# Technical Service Bulletin

**COMPLIANCE:** ADVISORY  
**SUBJECT:** LOWER IONIZATION DUE TO COILED HIGH VOLTAGE CABLES  
**AFFECTED UNITS:** ALL GPS-IMOD™ UNITS  
**DESCRIPTION:**

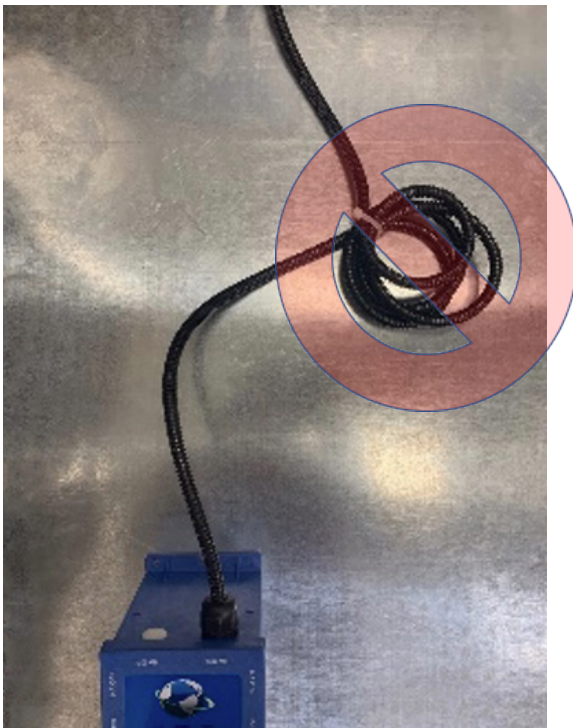
The coiling or bundling of high voltage (HV) cables can cause arcing and decreased ion output from the iMod. Installations where the cable(s) are touching in multiple locations will experience reduced output and lifespan. If the HV cable(s) is similar to the below picture, action is strongly recommended.

Do not cut or alter high voltage cables. Cables 15ft long can be ordered if additional length is required. Do NOT coil, bunch, or loop the cable up so that it comes in contact with itself. To reduce slack in the cable, create long sweeping "S" shapes, like switchbacks in a road. High voltage cable should be routed with soft bends only such as creating long sweeping "S" shapes. Minimum bend radius is 3". Maximum bend angle is 70 degrees. Secure the cable(s) so they will not interfere with or be damaged by equipment or personnel.

The proper routing of cabling is shown above.
